Structural Review

Refer to Existing Plans and Exterior Elevations marked up with our site observations following this narrative, along with our preliminary chapter 34 evaluation information. Text in bold represents our recommended scope of work.

Exterior Elevation Notes: Emery Grover Building, Needham, MA

WEST (FRONT) ELEVATION
 N.T.S.

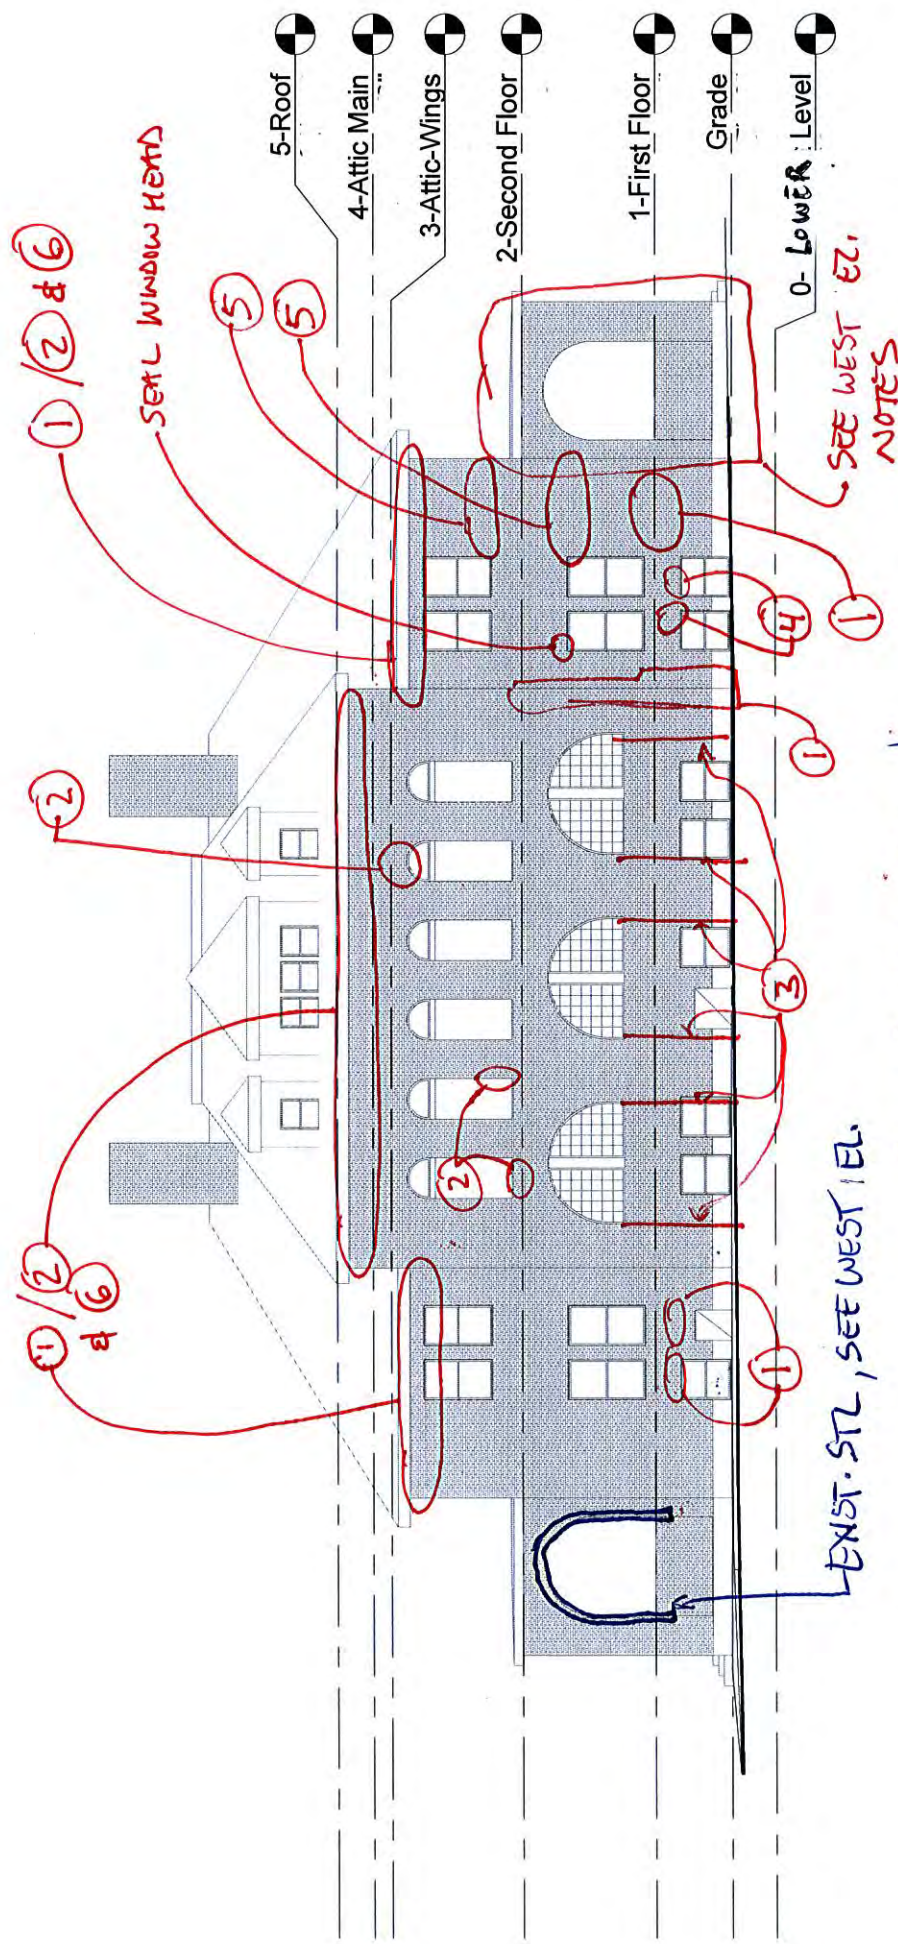
①/②
 TYP. ENTIRE CHIMNEY ALL SIDES

EXIST. TEMP. ARCH REINF. @ SOUTH PORTICO, WHERE BRICK WAS PREVIOUSLY PATCHED & RE-PAINTED. SEE NARRATIVE FOR REINFORCEMENT REINF.

REPAIR LOOSE/SPLIT/DAMAGED BRICKS & RE-POINT INTO EXT. OF ENTIRE WEST PORTICO AFTER REINF. ARCHES W/ STEEL TENSION RODS. SEE NARRATIVE.

EAST. (REAR) ELEVATION
 N.T.S.

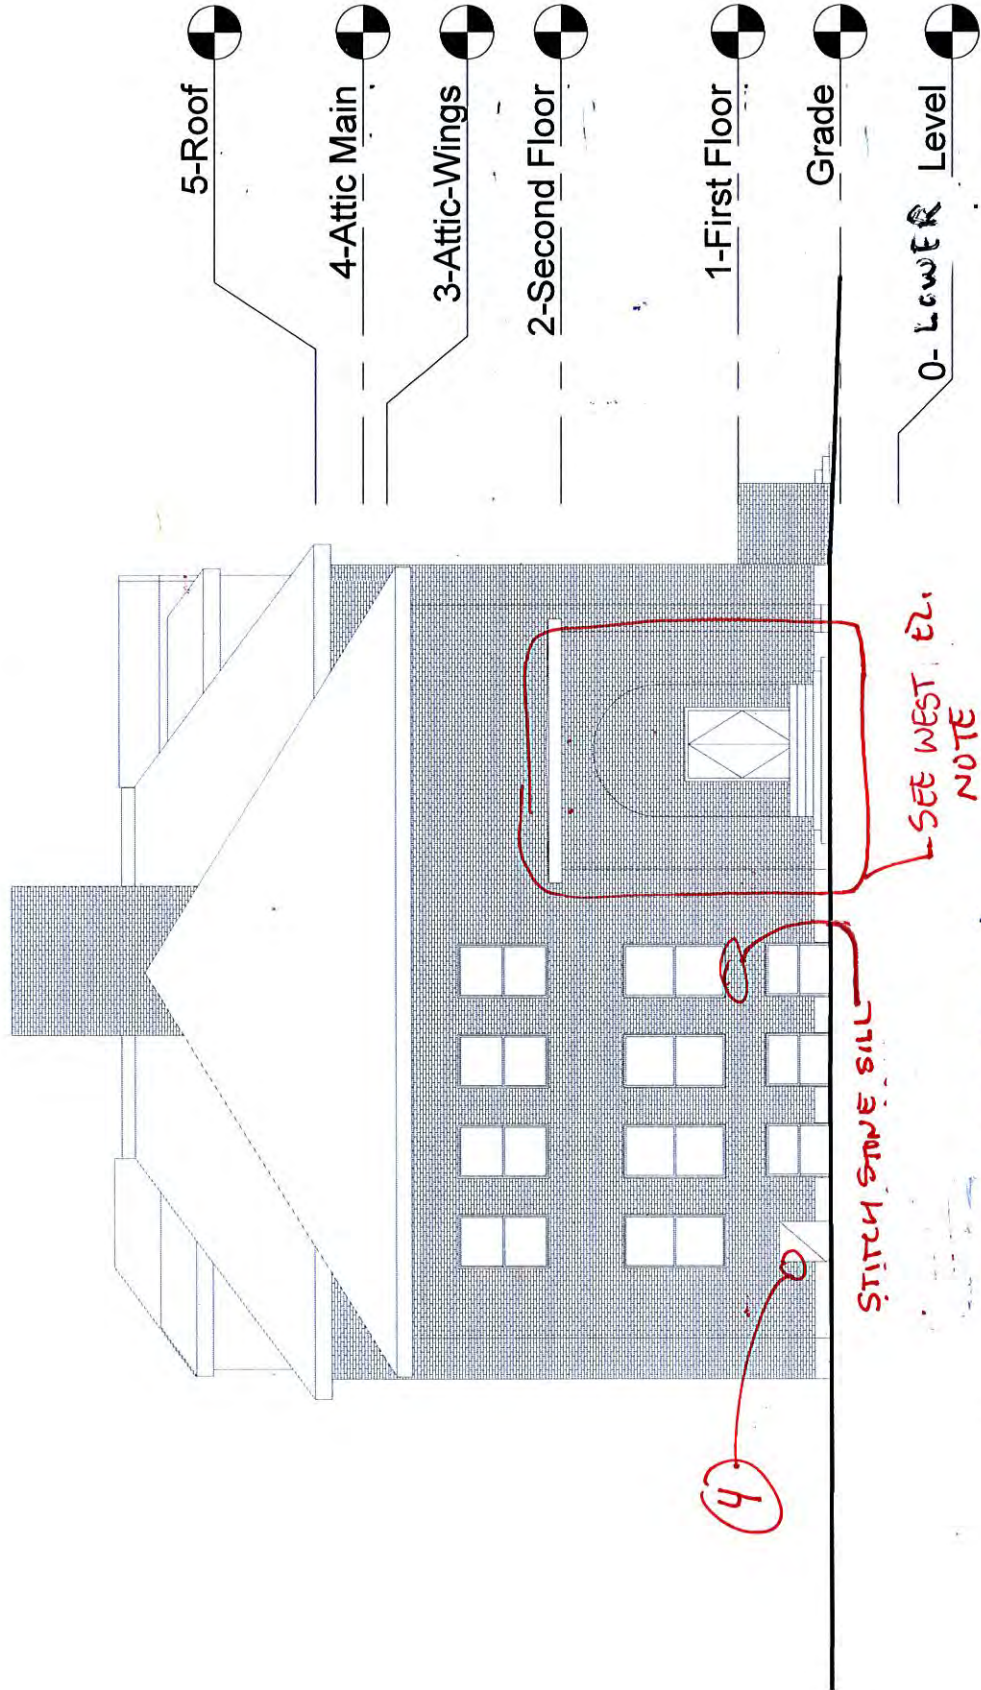
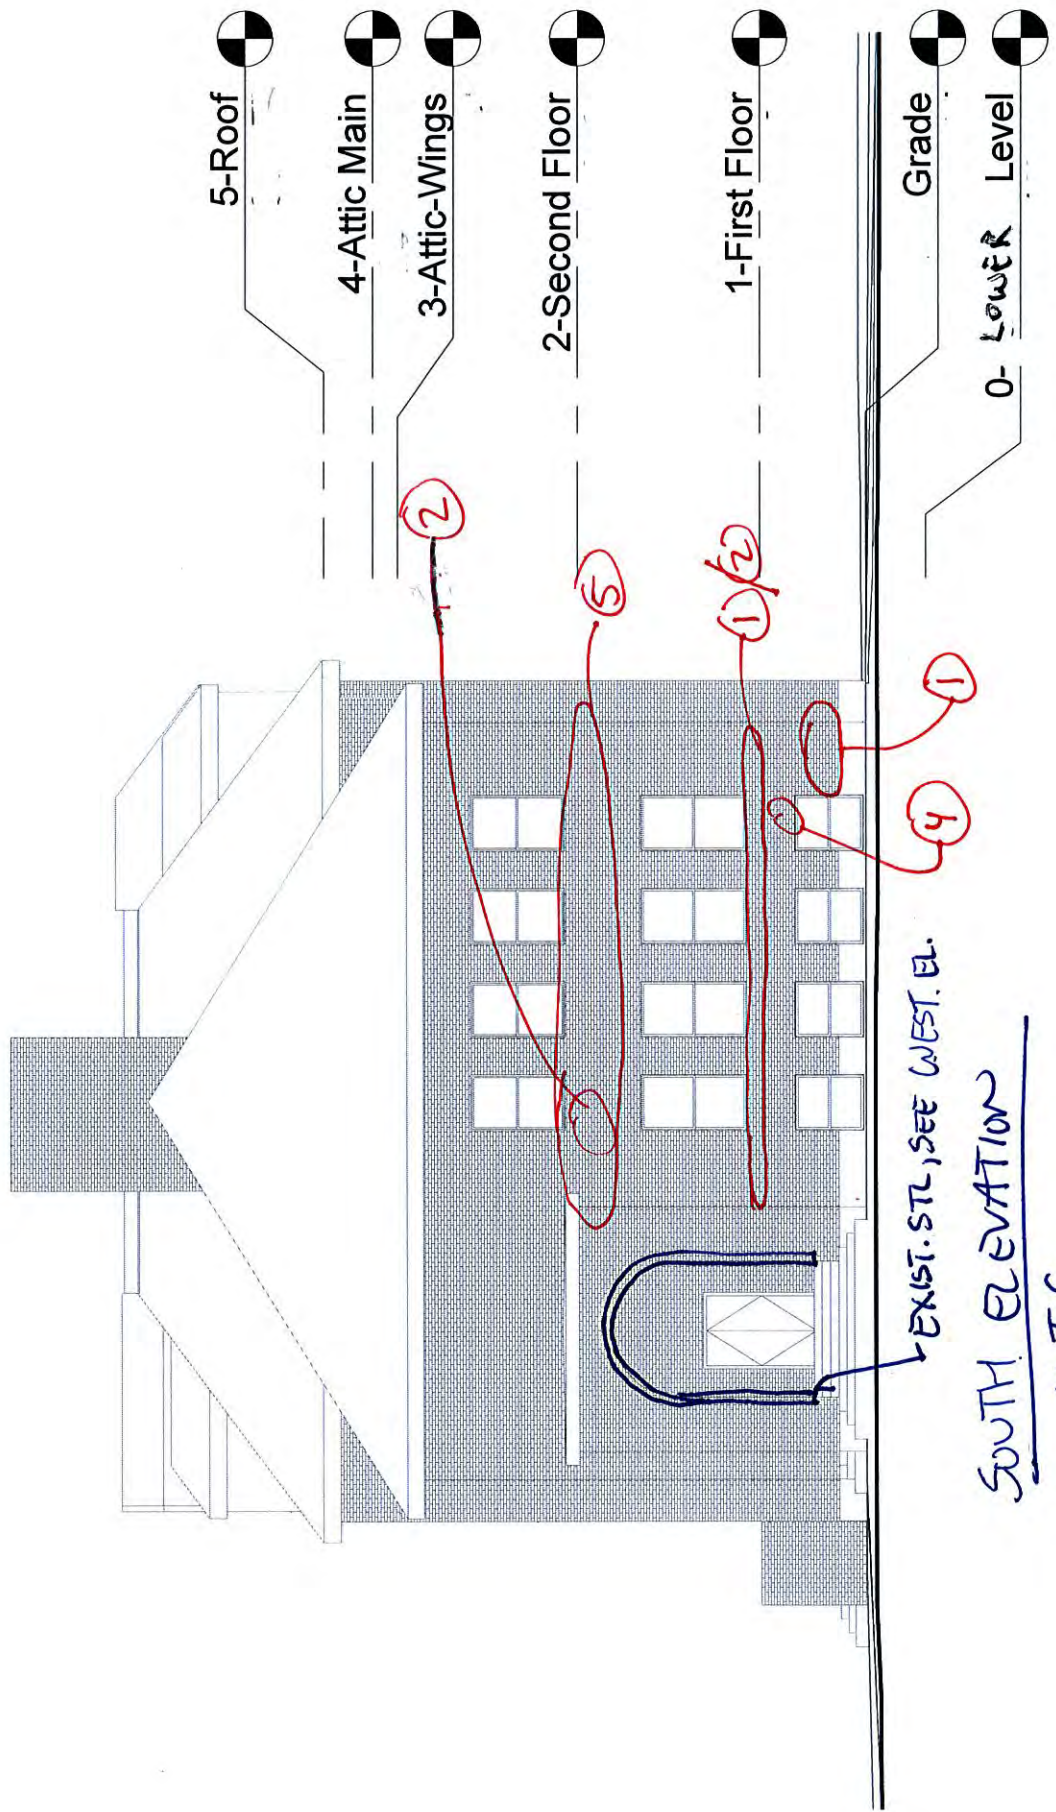
ALL ELEVATIONS: Investigate existing connection of veneer to backup. Smaller dimensions of veneer brick, combined with likely larger brick dimensions for backup brick, likely resulted in infrequent connection between veneer and backup. Assume pinning of veneer to backup will be required.
